Remedial Design Characterization Report for the Former Sanitary Landfill Lockheed Martin Corporation, Beaumont Site 1 Beaumont, California

Submittal of Revised Characterization Report for the Former Sanitary Landfill, Lockheed Martin Corporation, Beaumont Site 1, Beaumont, California

RESPONSE TO DTSC COMMENTS ON THE CHARACTERIZATION REPORT FOR THE FORMER SANITARY LANDFILL LOCKHEED MARTIN CORPORATION, BEAUMONT SITE 1, BEAUMONT, CALIFORNIA TETRA TECH, INC MAY 2009

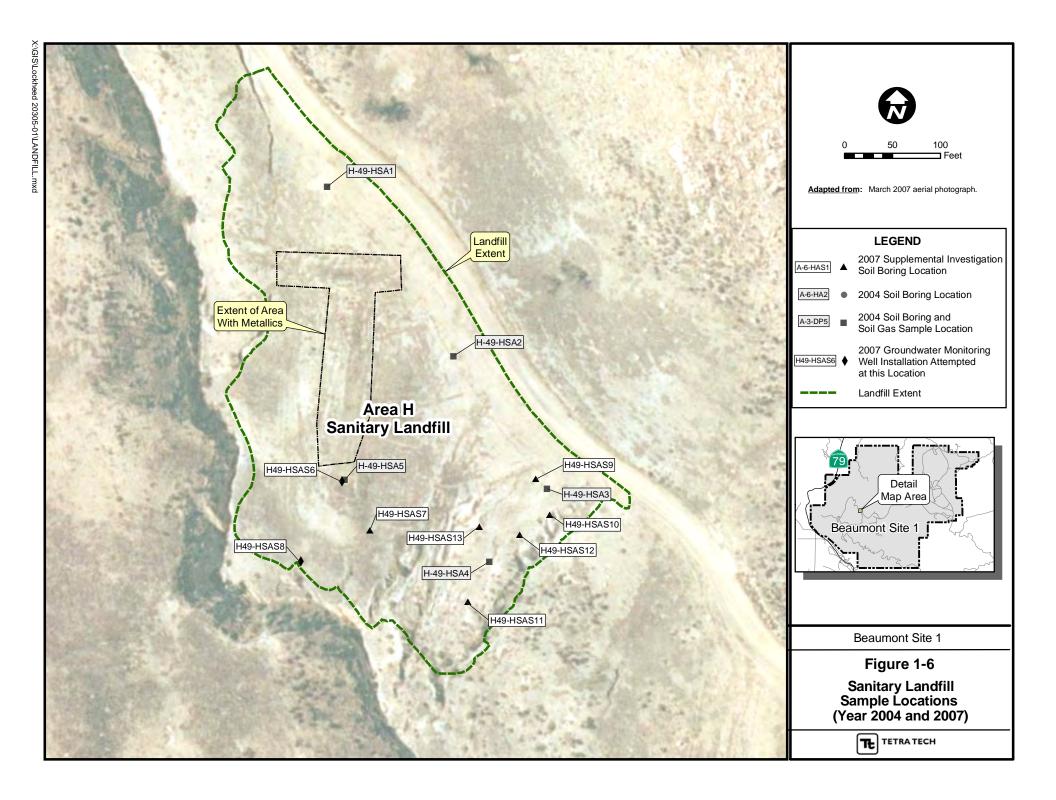
Specific Comments					
Comment	Response	Proposed Action			
1. Figure 1-6: Attempted groundwater monitoring well locations at H49-HSAS6 and H49-HSAS8 should be identified on the figure.	Tetra Tech concurs with this comment.	The figures will be modified to reflect this comment.
